CALIFORNIA COASTAL COMMISSION

STAFF REPORT: REGULAR CALENDAR

Application No.: 5-11-053

Project Location: Selva Road & Pacific Coast Highway, Dana Point (County of Orange)

Exhibit #2 – Site Plan/Elevation Plan

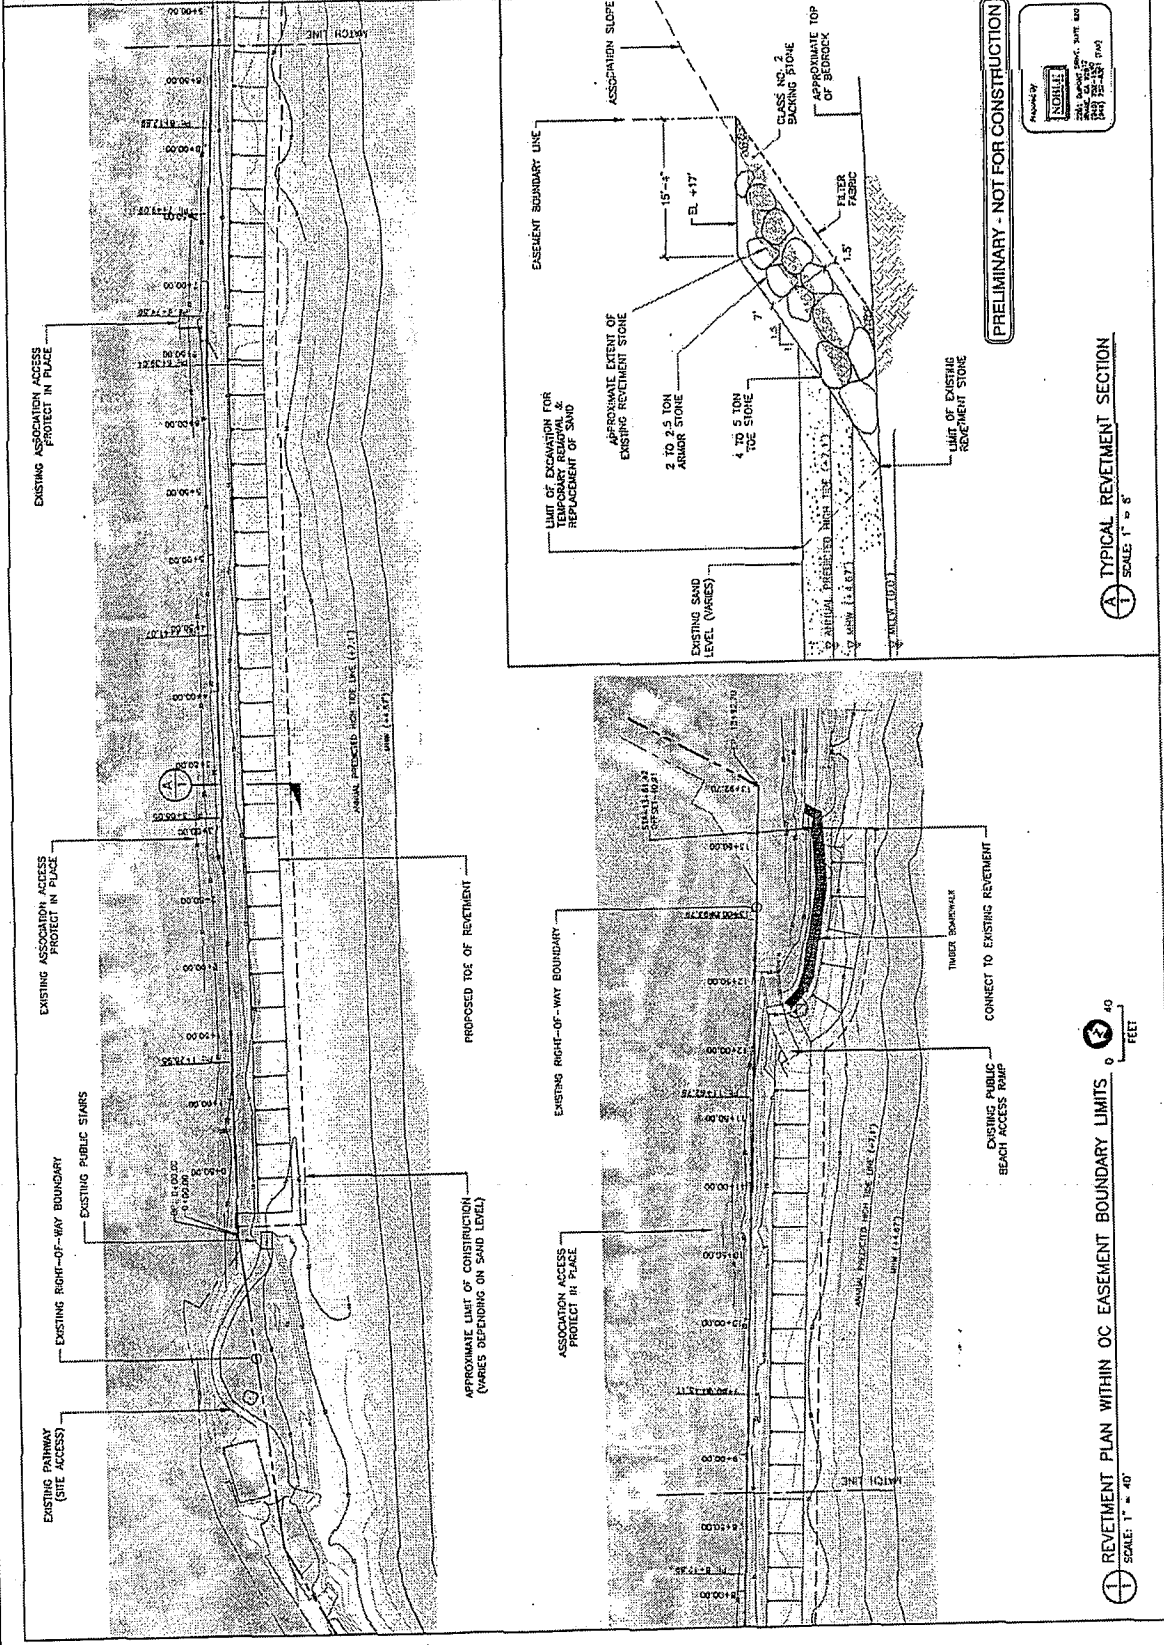
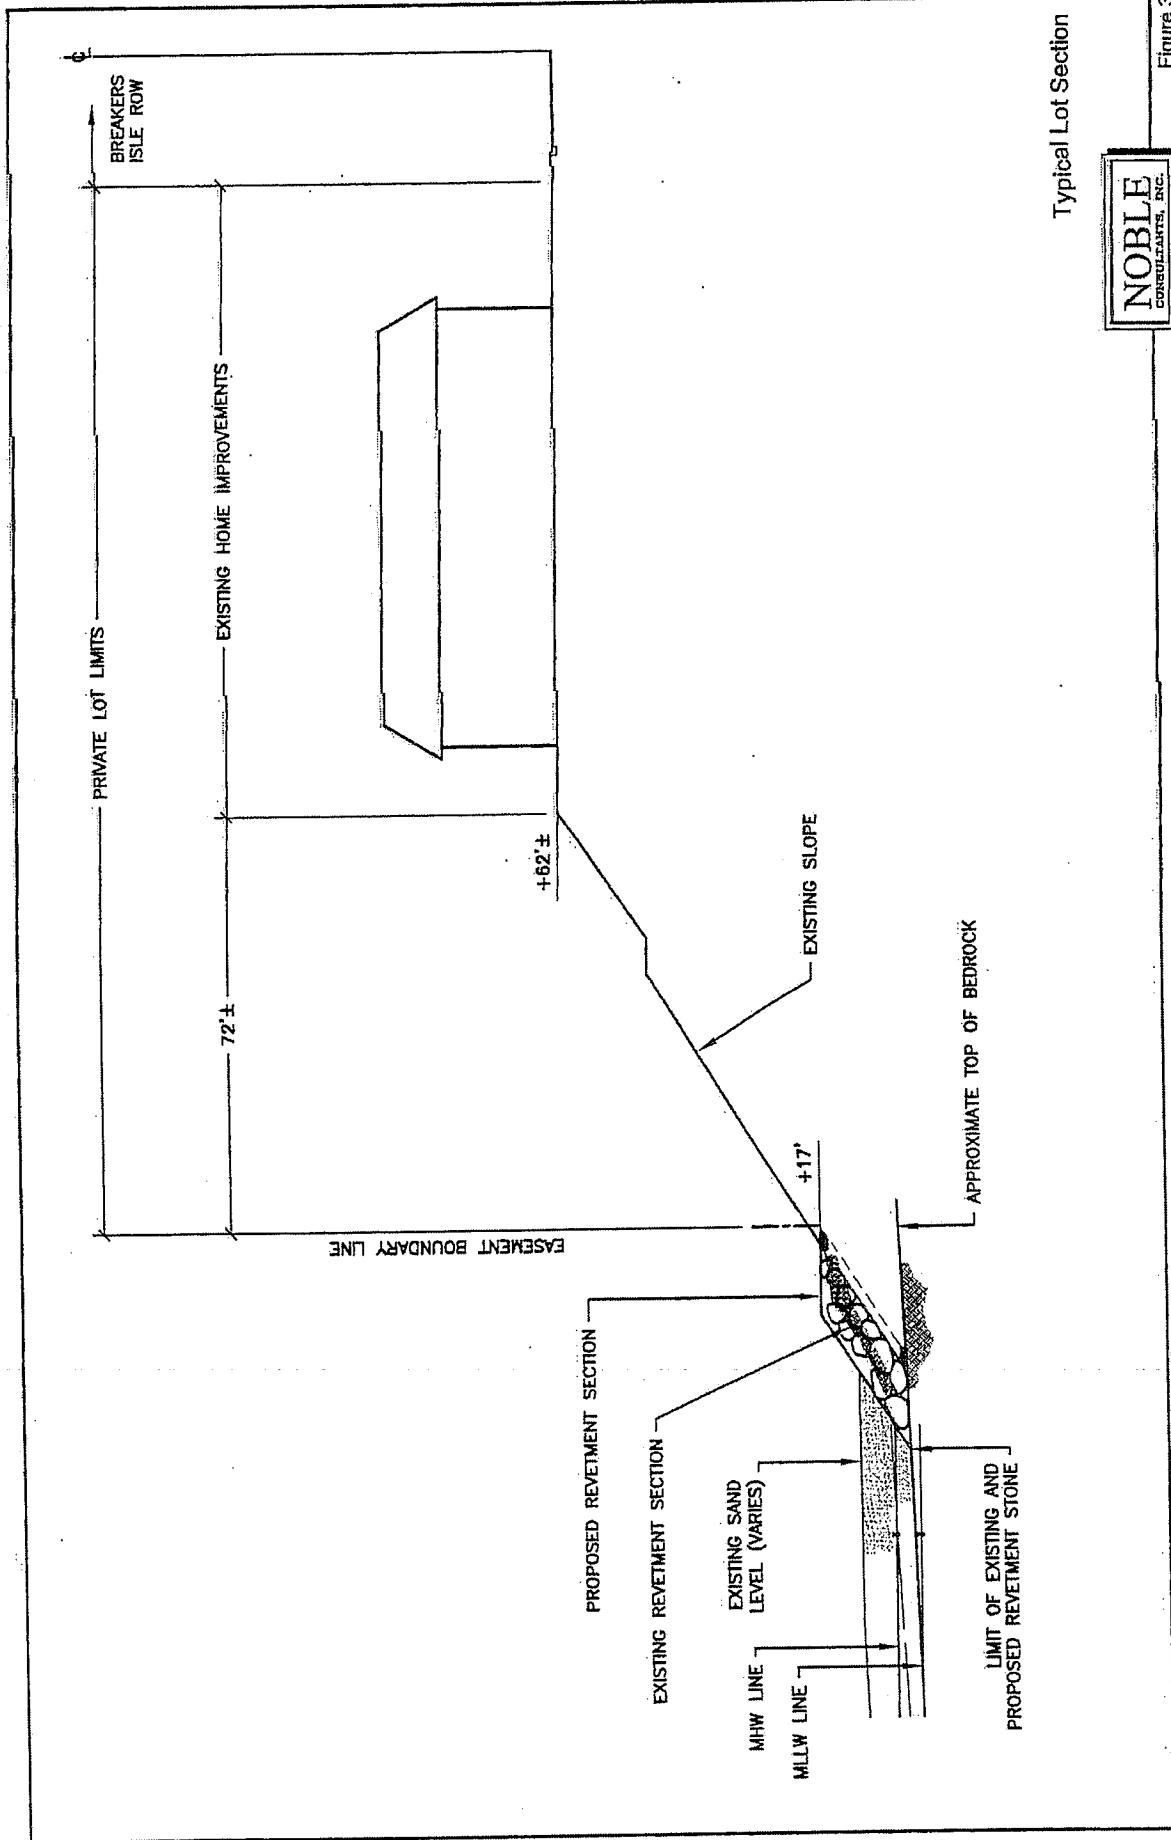
seaward limit of the original revetment or the limit of the existing rock. There seems to be no reason that the proposed revetment needs to be as far seaward as proposed, other than the unwillingness of the back shore property owners to allow a more landward location.

As proposed, the revetment footprint will be approximately 15.4 feet seaward of the bluff face and will protect approximately 1,400 feet of bluff length. The construction of the new revetment will cover approximately 21,560 square feet of beach. The revetment will also fix the back bluff location and prevent inland migration of the beach. The long-term average annual erosion at this location is approximately 0.19 feet/year. Over a 20 year time period (the life of structure assumed for most shore protection), the revetment will prevent the creation of approximately 5,320 square feet of beach. Thus construction of the revetment and fixing the back beach location will result in the long-term loss of 26,880 square feet of beach area.

The proposed revetment design is limited to a height of only +17' NAVD. The applicant's analysis of storm activity shows that this revetment is not an optimal engineering design and that the proposed configuration will experience overtopping for moderate to severe storm events. The proposed revetment design would use armor stone of sufficient size so as to remain stable during a large storm; however, the unprotected back slope can be expected to experience erosion from overtopping even

For enhanced bluff protection, the revetment would need to be closer to the bluff face and it would need to extend farther up the bluff face than does the proposed design. There appears to be adequate space between the back bluff development and the toe of the bluff to accomplish this redesign. Such a landward relocation would have less encroachment onto public beach and would afford better protection to the inland development in need of protection. Although a vertical wall would be another option that would bring the protection closer to the bluff and that could extend higher onto the bluff face, the identified constraints to installation of a vertical wall - very hard bedrock that would be difficult to excavate and a deep sand channel about -18 feet deep that would need to be completely filled to prevent scour - make a vertical wall very impractical for this location.

Staff believes several key changes are needed to address these issues. First, the applicant must consider relocating the revetment further landward, and to increase its crest elevation. The proposed revetment encroaches onto public beach area. Furthermore, the proposed crest elevation is too low to prevent overtopping during storm events, which will erode the bluff slope and necessitate an extraordinary amount of maintenance on the revetment itself. Relocating the structure landward would move the structure inland, perhaps as much as 5 to 10-feet, reducing, but not eliminating encroachment on the public beach. Along with this relocation, the crest elevation of the structure could be increased so that wave overtopping would be minimized. This will provide greater protection of the bluff slope, and a lesser maintenance regime.
